70206A-04A

S E R V I C E N O T E

HP 70206A System Graphics Display

ROM Replacement Kit

**Figure 1****NOTE**

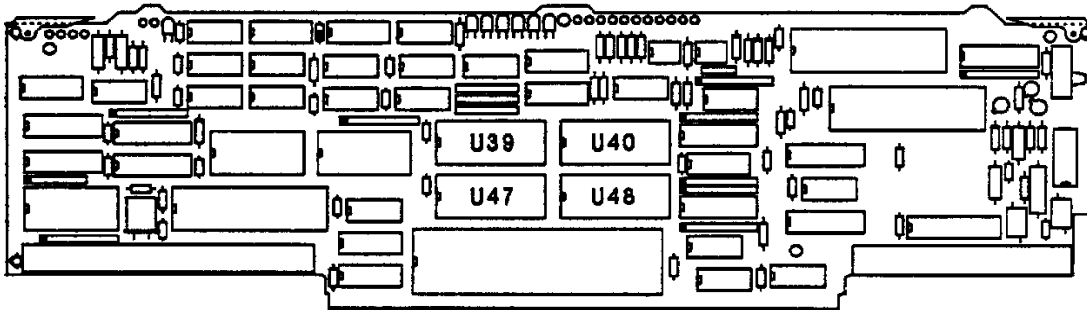
6. Locate (do not remove) the ROMs on the microprocessor board (U39, U40, U47, U48), and note their notch orientation. The original ROMs currently in the board should have HP Part Numbers 70205-80004 through 70205-80007. The new ROMs have HP Part Numbers 70205-80037 through 70205-80040 respectively. See Figure 1.

7. Remove original ROM U39, 70205-80004, and replace it with new ROM 70205-80037. Place the original ROM in the anti-static foam block, then repeat the sequence for U40, U47, and U48 so that the following list is satisfied.

U39 70205-80037
U40 70205-80038
U47 70205-80039
U48 70205-80040
